Access Compliance Report

Public Rights-of-Way

(Curb Ramps)

Intersection ID: 8296	Main Street: N_CRIGLER_ST	Cross Street: ROZZELLES_FERRY_RD	Location: NW
ADA ID: D51F15485474	Ramp Type: Directional1	Initial Pass/Fail: Fail	Overall Compliance: No
Severity Score: 12.5			
Codes/Mitigation Info/Possible Solution		Field Measurements/Component Compliance

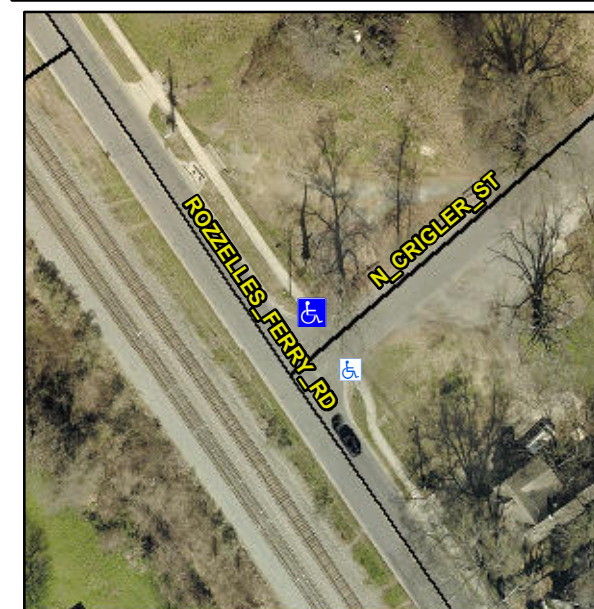
R304.2.2

Compliance	Description	Data	Compliance	Description	Data
N/A	Ramp Length (in)	93.0	N/A	Grade Break?	N/A
Yes	Ramp Width (in)	70.0	N/A	Grade Break Slope (%)	0.0
No	Ramp Slope (%)	8.6	N/A	Grade Break XSlope (%)	0.0
Yes	Ramp XSlope (%)	0.1			
N/A	Flare Type LT	N/A	N/A	Flare Type RT	N/A
N/A	Flare Slope LT (%)	N/A	N/A	Flare Slope RT (%)	0.0
N/A	Flare Traversable LT?	N/A	N/A	Flare Traversable RT?	N/A
N/A	Landing Length (in)	0.0	N/A	DWS Provided?	N/A
N/A	Landing Width (in)	0.0	N/A	DWS Contrast?	N/A
N/A	Landing Slope (%)	0.0	N/A	DWS Length (in)	N/A
N/A	Landing X Slope (%)	0.0	N/A	DWS Full Width?	N/A
N/A	Landing Curb? (Y/N)	N/A	N/A	DWS Offset LT (in)	N/A
N/A	Shared Landing?	N/A	N/A	DWS Offset RT (in)	N/A
N/A	Gutter Ponding?	0.0	N/A	Gutter Slope (%)	N/A
N/A	Gutter Lip Ht (in)	0.0	N/A	Gutter X Slope (%)	N/A
N/A	Painted X Walk1?	No		Road Slope (%)	1.6
	X Walk 1 Direction	To SE		Road X Slope (%)	2.3
	X Walk 1 Width (in)	N/A		Clear Space?	N/A

X Walk 1 Slope (%)	1.6	N/A	Clear Space to XWalk (in)	N/A
	X Walk 1 X Slope (%)	2.3	N/A	Storm Grate/Utility Hazard?	N/A
N/A	Ramp inside XWalk1?	N/A		Storm Grate/Utility Type	
N/A	Any Obstructions?	N/A			N/A
	Obstruction Type		Yes	Surface Condition? (G/P)	Good
			N/A	Curb Slope (%)	11.5

Remove & Replace Entire Ramp.
